WEST RIDGE MINE

**SUBMITTAL OF APPENDIX 5-19
DEFICIENCY RESPONSE MARCH 22, 2012
TASK ID#4010**

**TO ALLOW TEMPORARY
RE-OPENING OF THE
“B” CANYON PORTAL**

Deficiency List
Task N. 4010
Re-Opening of B Canyon Portal

DRAWN BY	PJ	SCALE	1" = 20'
APPROVED BY	DH	DATE	14 MAY 2012
REVISION	3	SHEET	PLATE #2 of 2

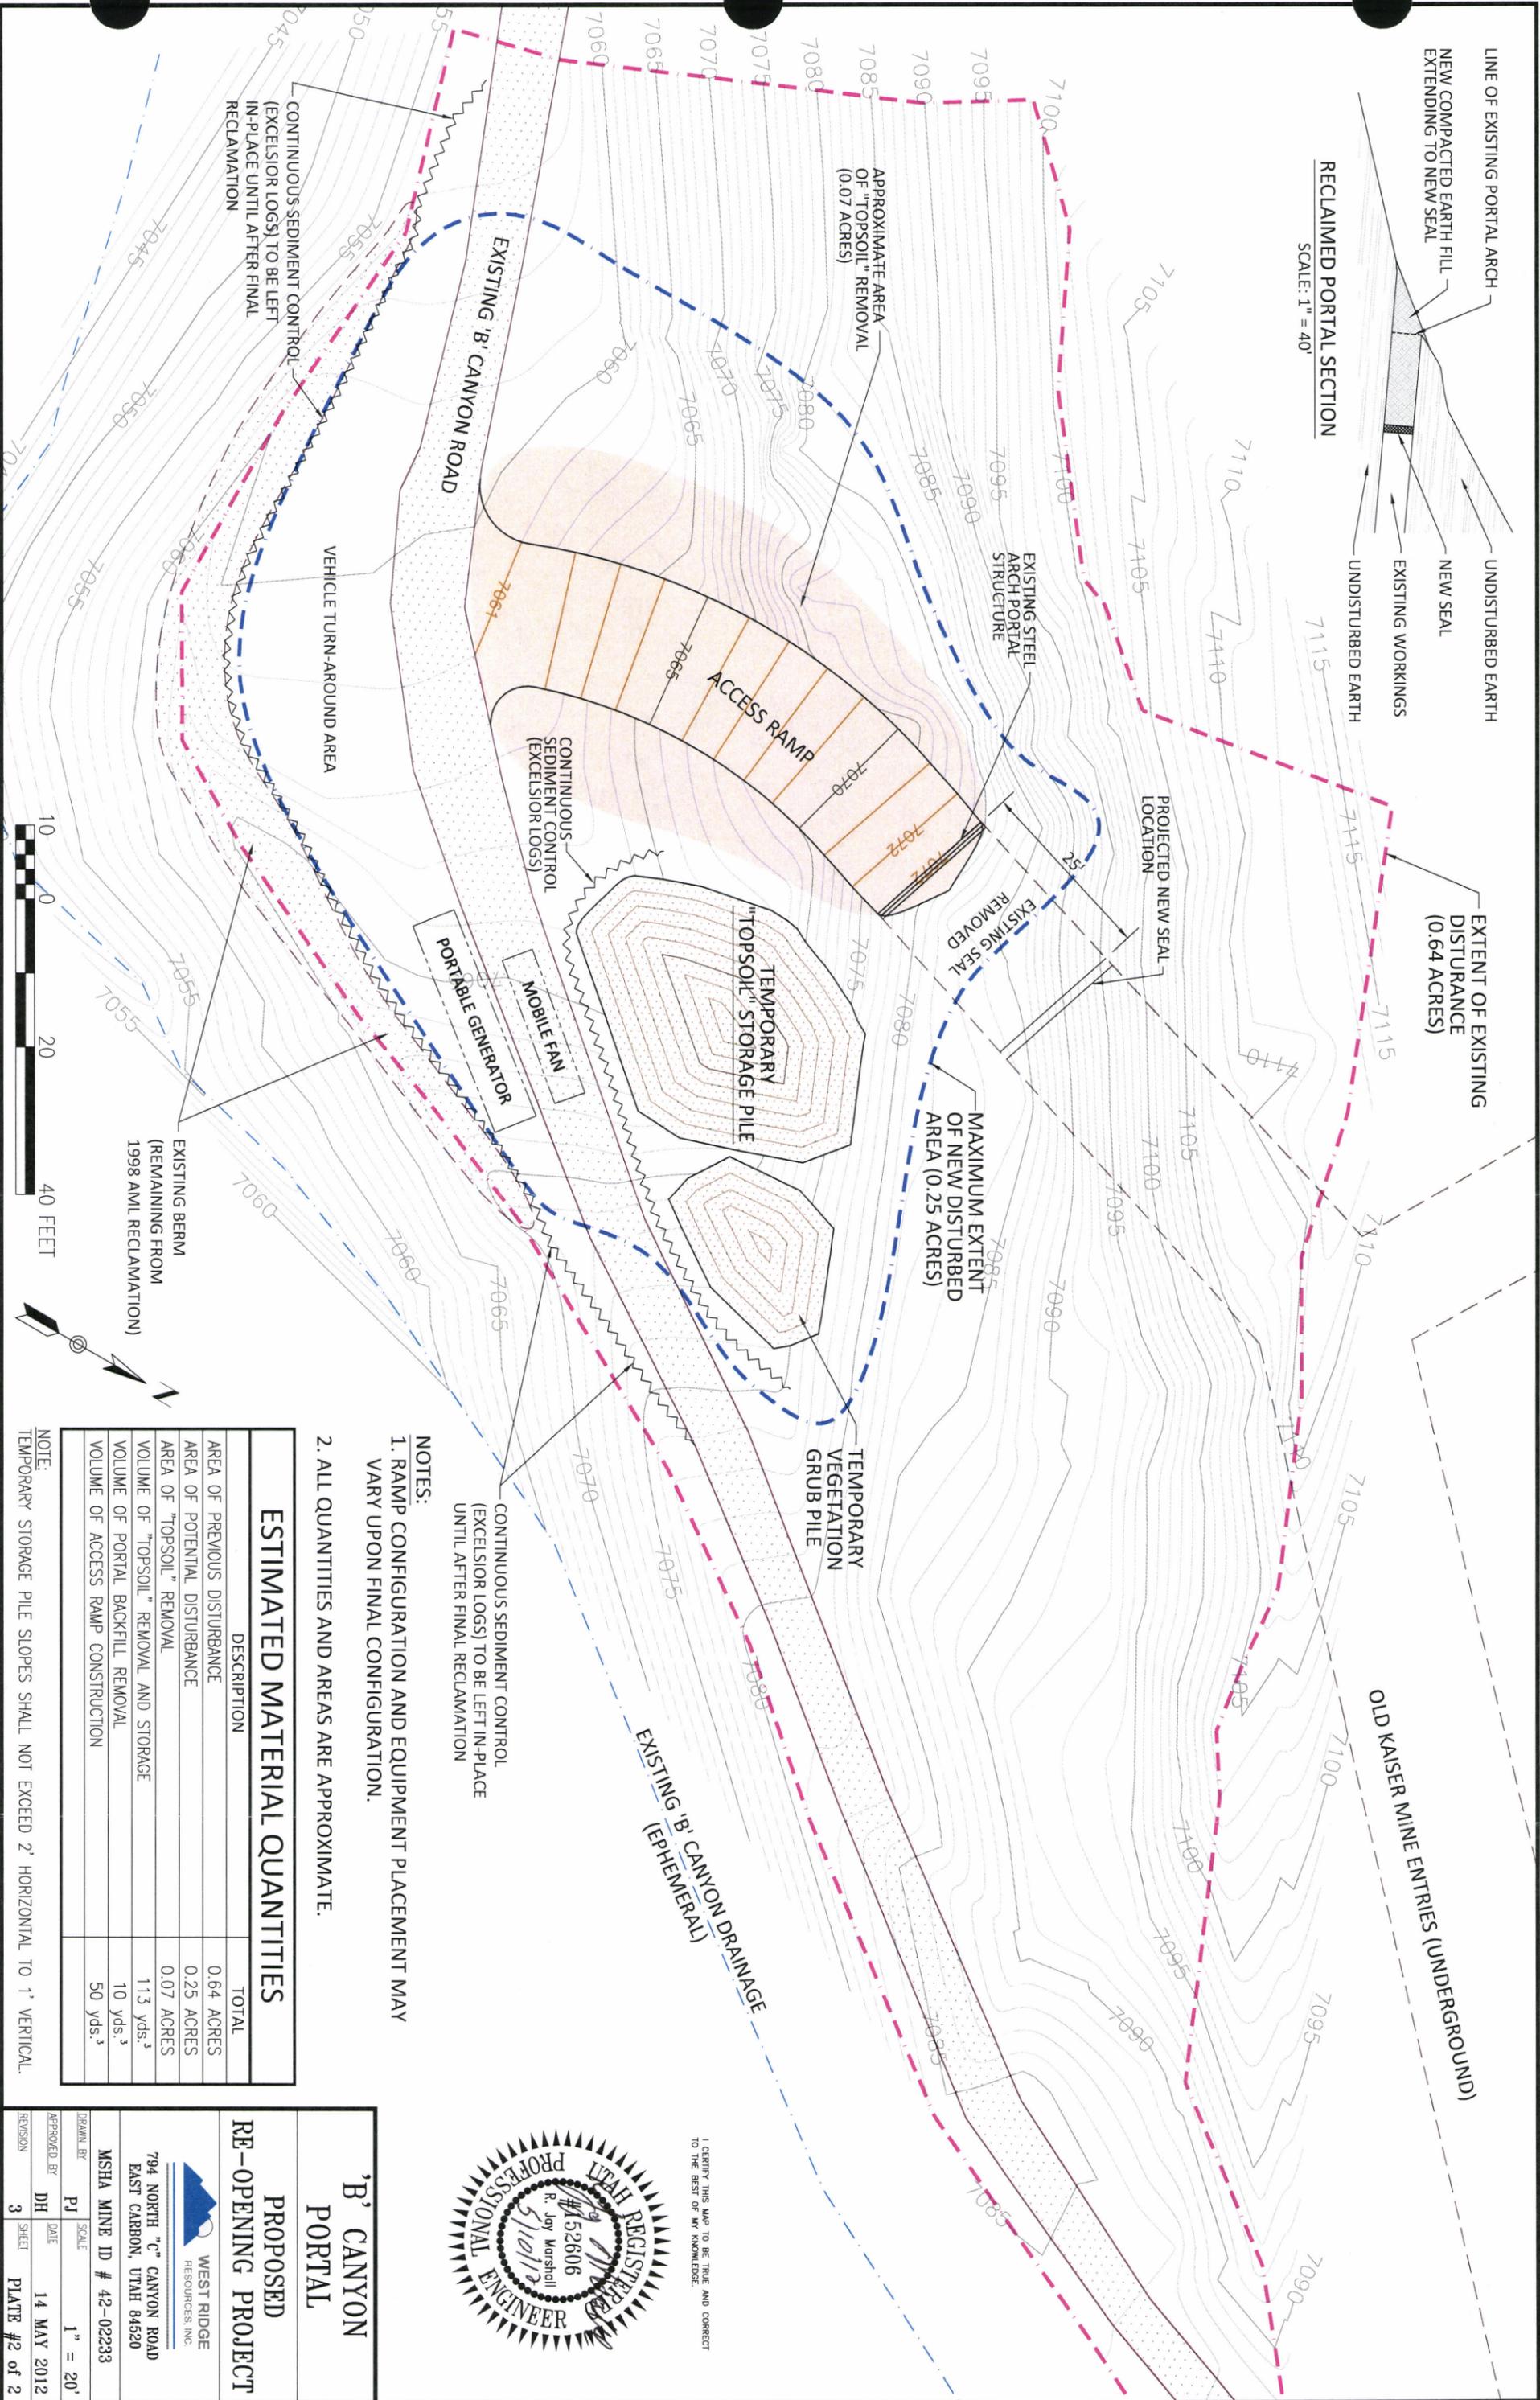
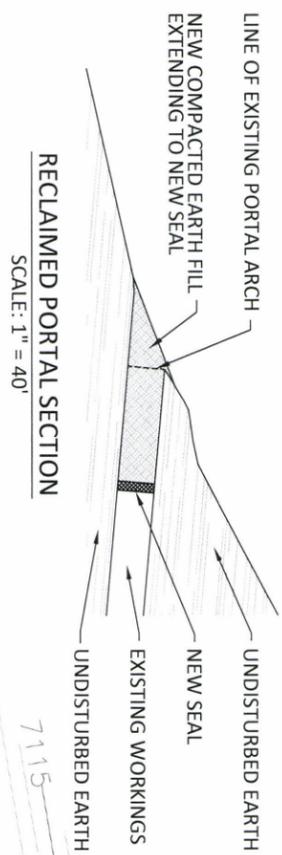
R645-301-742: The permittee must provide additional information/clarification as to the sediment control measures to be implemented at the proposed project site. Plate #2 of 2 in Attachment 10 must be revised to clearly identify that excelsior logs will be utilized as the 'continuous sediment control' at the base of the temporary topsoil storage pile and directly adjacent to the B canyon drainage. (SC)

R645-301.513.500; R645-301.551 The applicant must include a commitment to backfill the portal opening to a minimum of 25 feet. The applicant must also include a cross section drawing that depicts the 25 feet of backfilled material as well as the locating of the seal as it will be at the portal's reclaimed configuration. (JO)

Plate #2-2 of Attachment #10 has been revised to clarify that the excelsior logs would be used for continuous sediment control and be left in place until after final reclamation.

The text has been revised in Chapter 5 of Appendix 5-19 to reflect "The portal opening will be backfilled from the portal opening to a minimum of 25 feet (see Plate 2 of 2)" Also a cross section depicting the 25' fill and seal location has been added to Plate 2 of 2.
